**Service Bulletin:** SB407-101; Bell 407 Air Conditioner Compressor Drive Pulley.

**Subject:** Inspection & Torquing Procedure for the Air Conditioner Compressor Drive Pulley Installation.

**Date:** 4 March, 1999  
28 Sept. 2000, Rev A

**Applicability:** Bell 407, Equipped with the Air Comm Corporation 407EC-201 Air Conditioner System.

Figure 1 Compressor Drive Pulley Installation Details

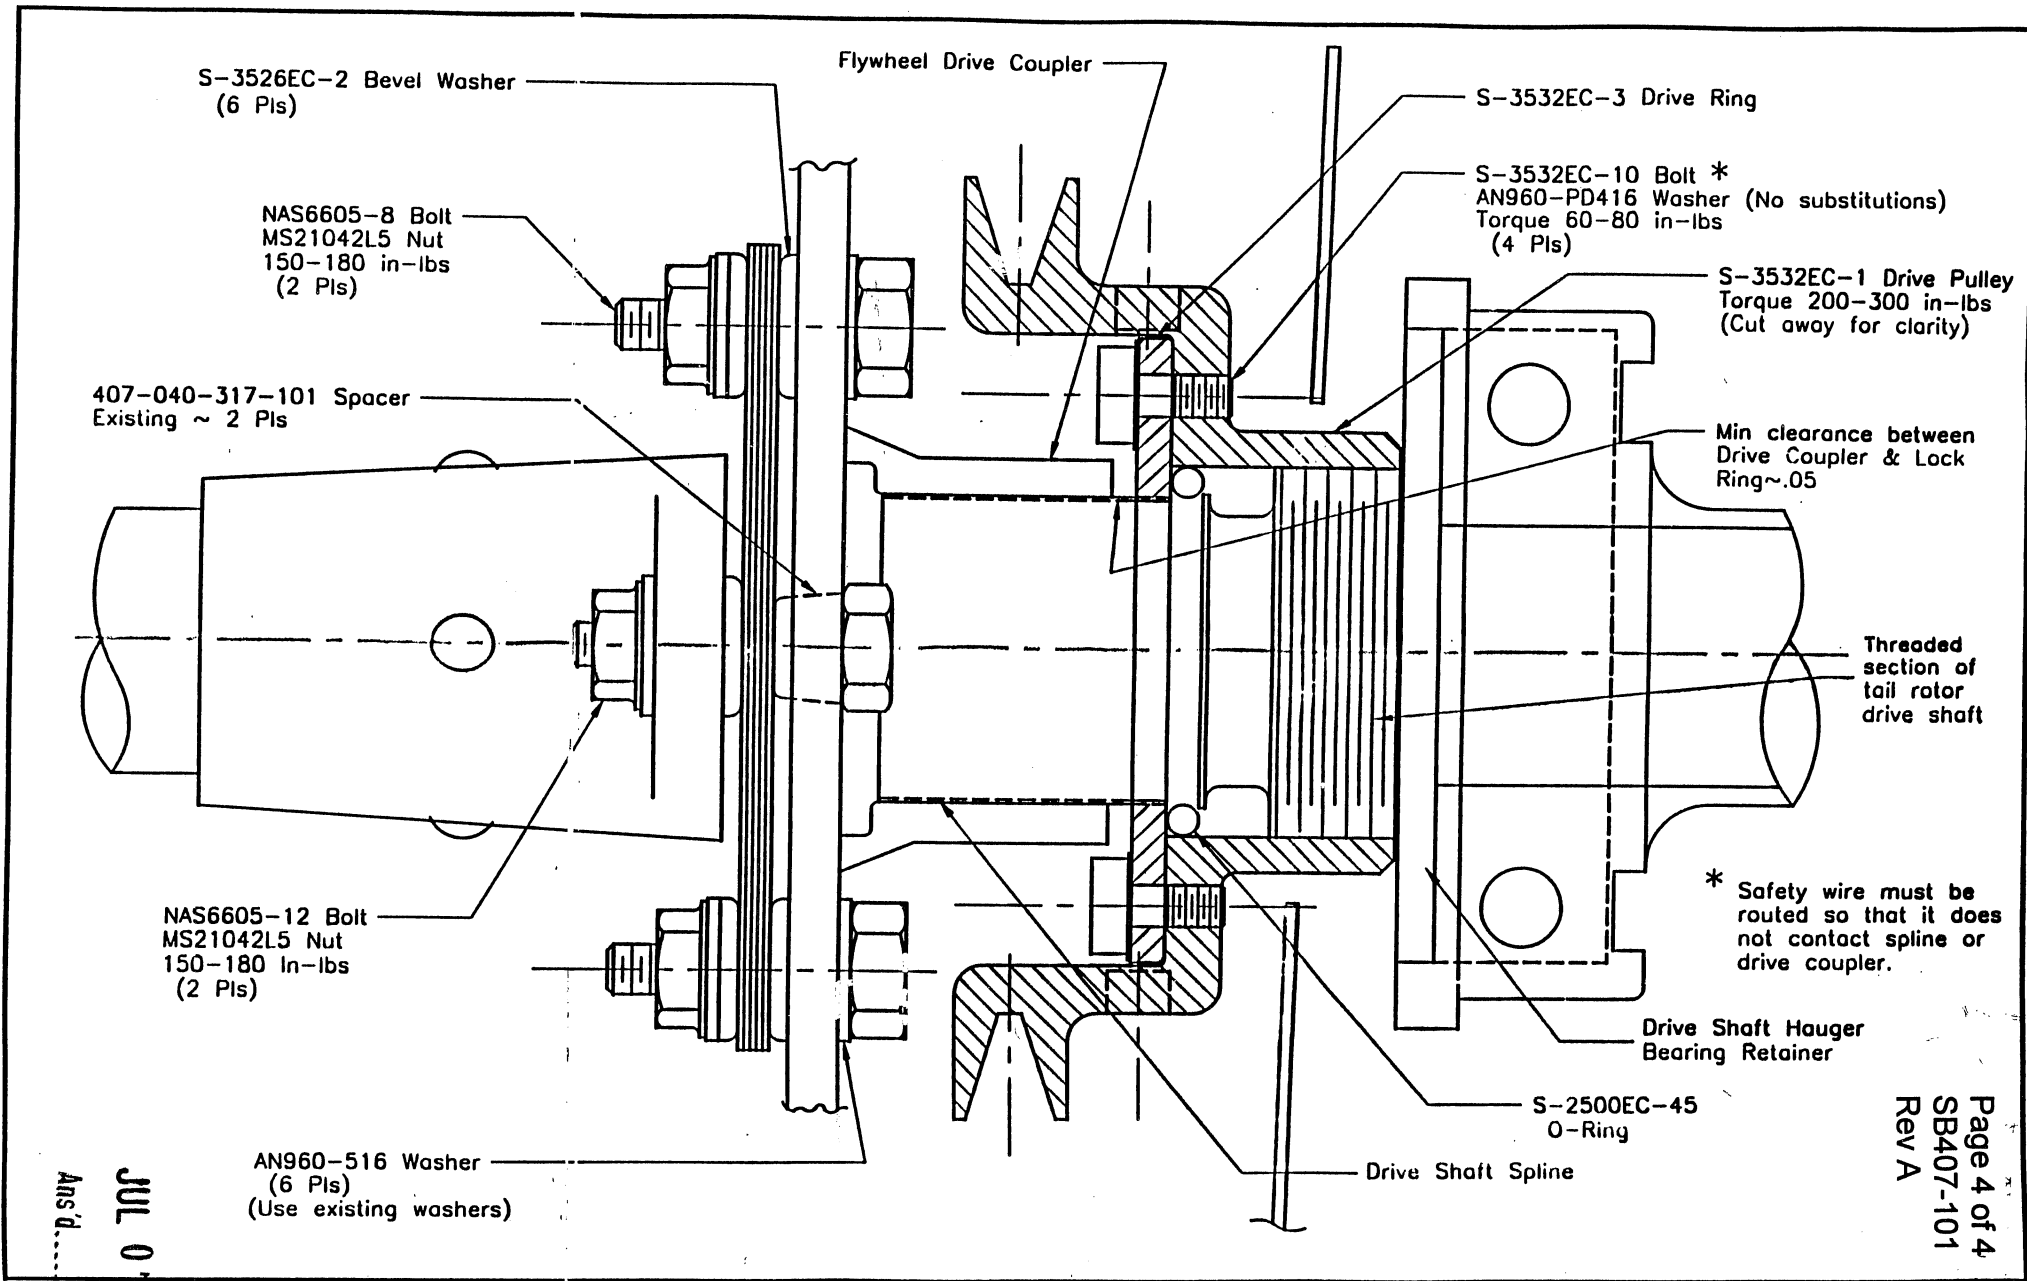
- e. Install Flywheel Drive Coupler, Flywheel and existing Drive Shaft mounting hardware as shown on Page 4 of 4, torque nuts to 150 –180 in lbs.

Minimum clearance between the Flywheel Drive Coupler, and the Drive Ring is .050 inch.
